Baldwin Planning Board Meeting Minutes

APPLICATION FOR CONDITIONAL USE PERMIT (CUP)

D&D OIL
534 PEQUAWKET TRAIL
WEST BALDWIN, ME

Re: Supplemental Submission
Proposed Bulk Oil Storage Facility
D&D Oil
Route 113, West Baldwin, Maine
St.Germain Collins File No.: 4076

FIGURE 4

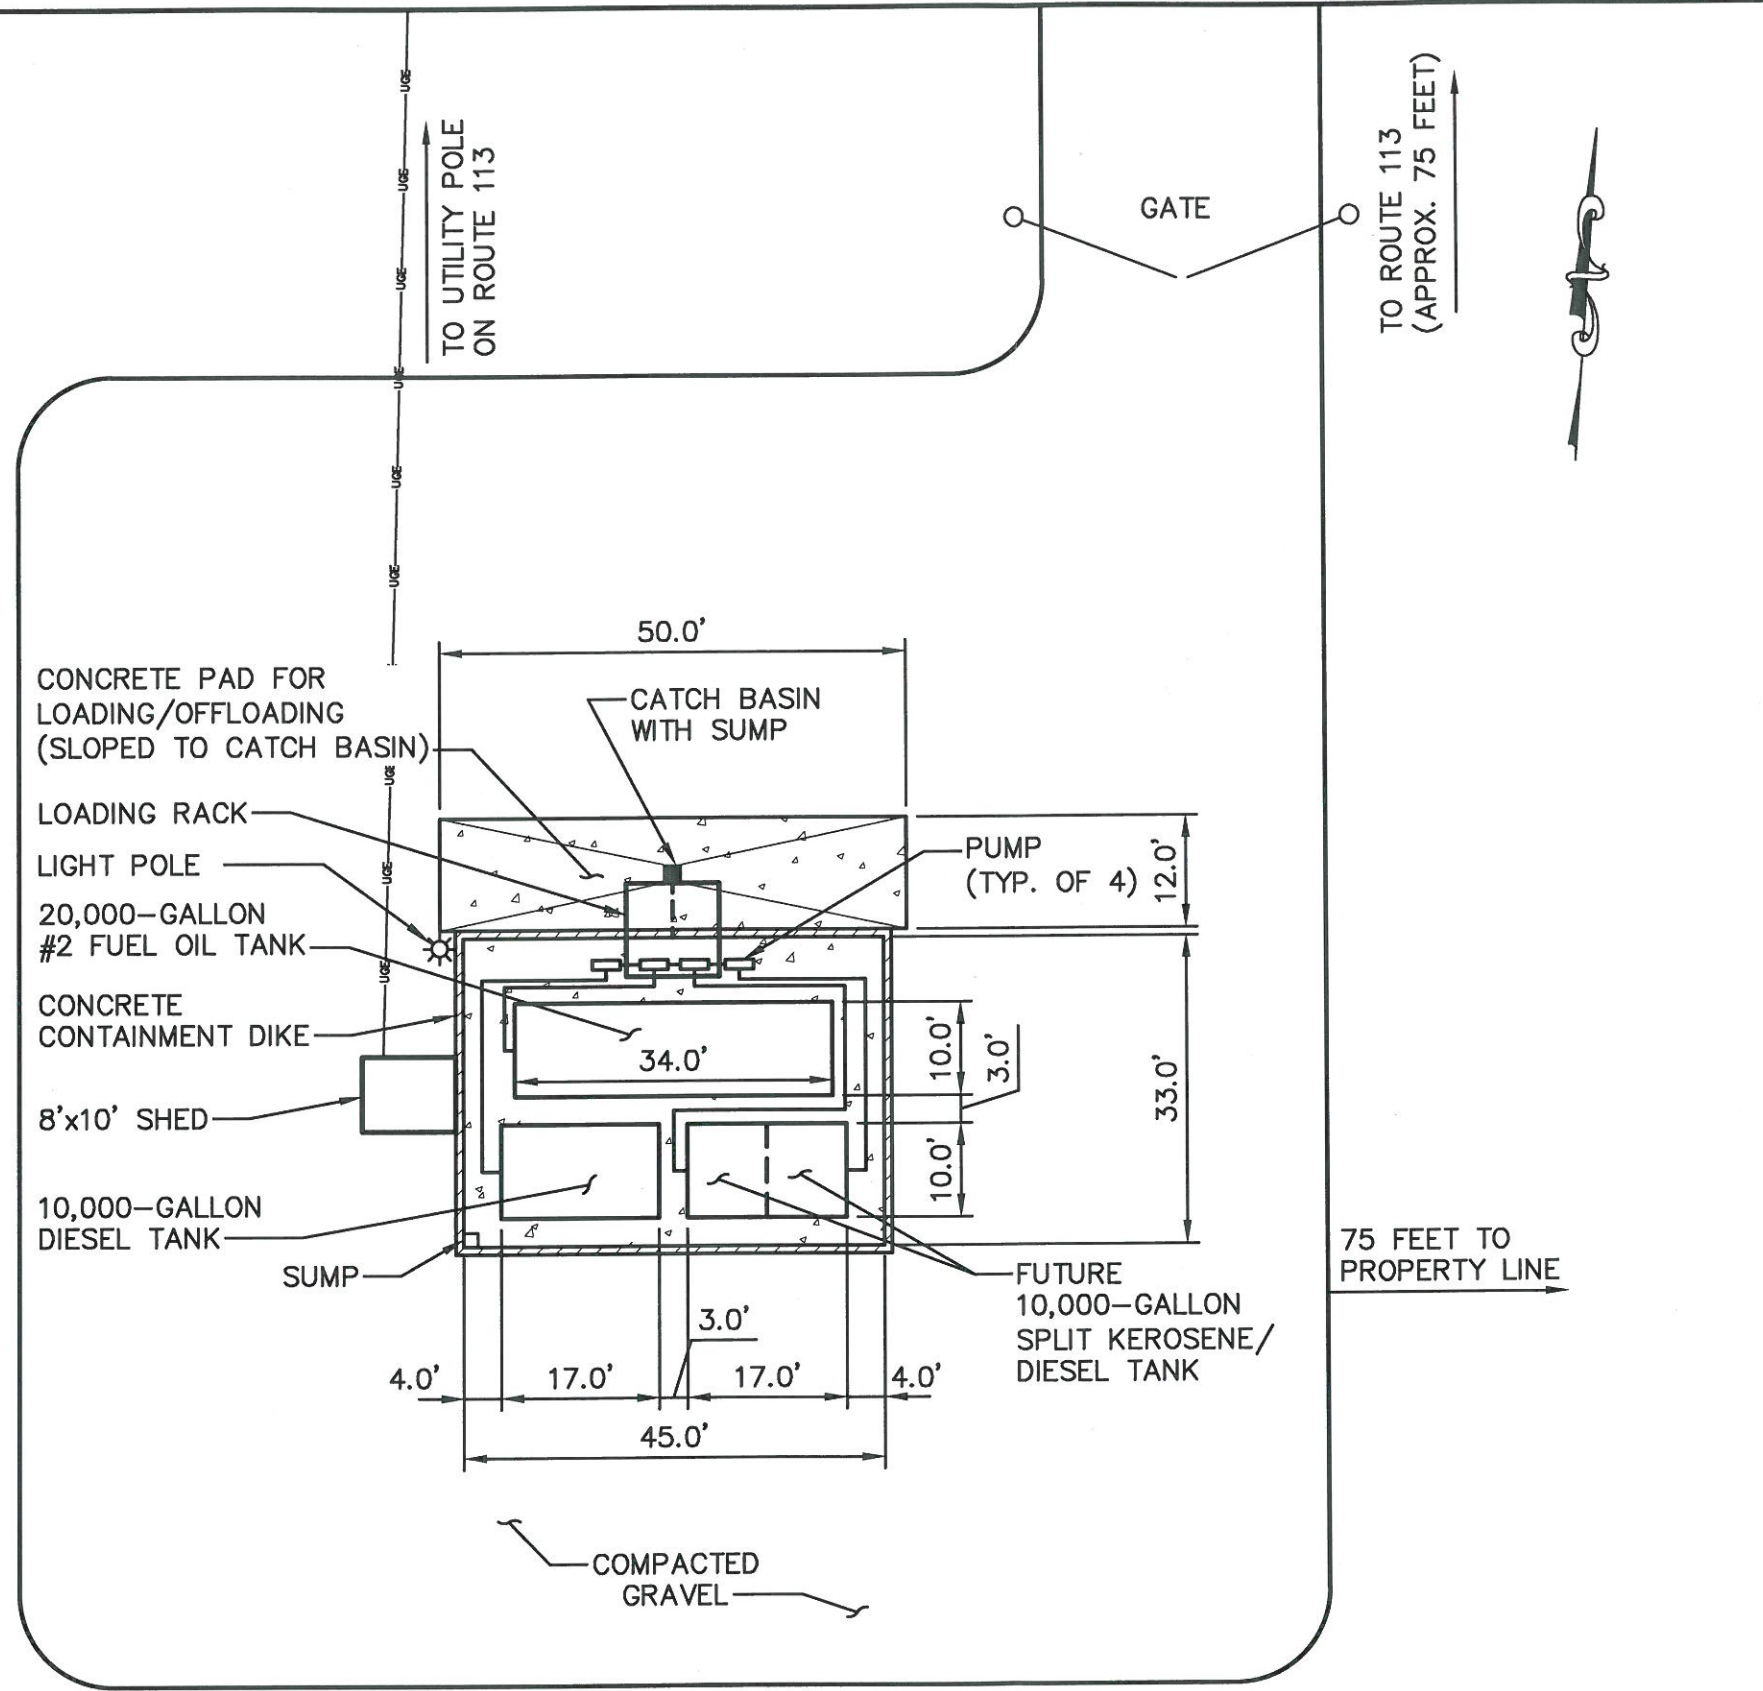
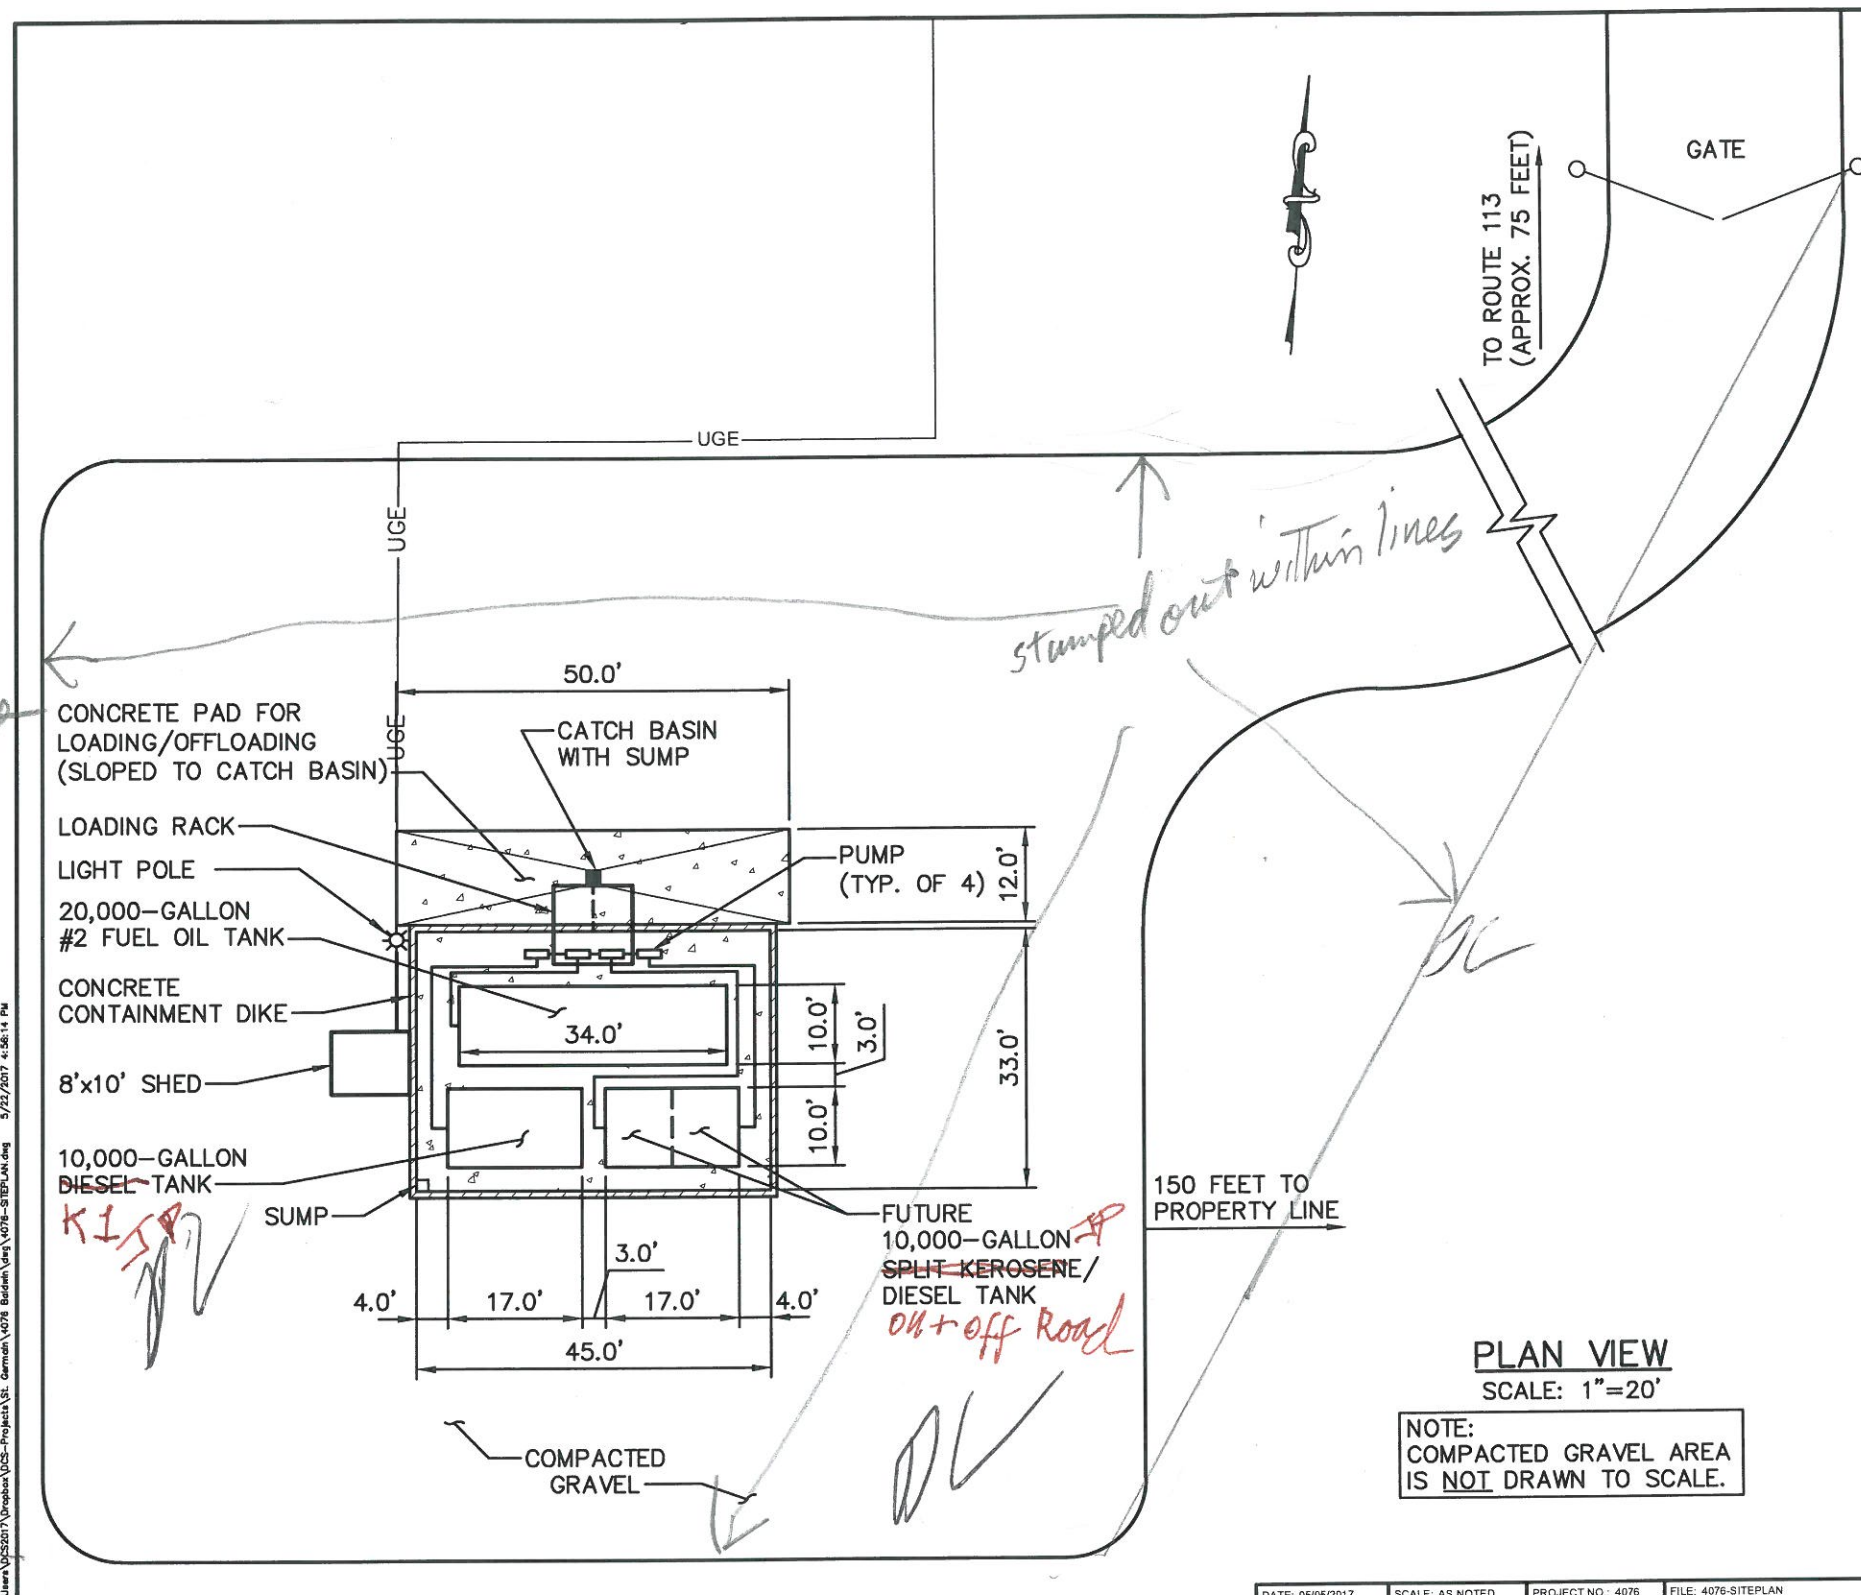
- N.B. Reference St.Germain-Collins Figure 4 (page 8) in CUP (initialed by applicant) East Gate post to SE corner – clear out that triangle.
- Plant and maintain a double-staggered row of ≥ 6 foot white pines as a visual barrier between the facility and the road.

- N.B. Reference St.Germain-Collins Figure 4 (page 8) in CUP (initialed by applicant) East Gate post to SE corner – clear out that triangle.
- Plant and maintain a double-staggered row of ≥ 6 foot white pines as a visual barrier between the facility and the road.

1. Can a Site Plan be provided with more detail? *Figure 4 is enclosed.*
2. Can shed location be shown on Site Plan? *Shed shown on Figure 4.*
3. Will trucks be parked at the facility? *Yes, there is a possibility that up to two delivery trucks will be parked at the facility during nighttime hours.*

7. Can a low-intensity light be installed? *One pole light will be installed, see Figure 4 and enclosed cut sheet for proposed pole-mounted light (or similar equivalent).*
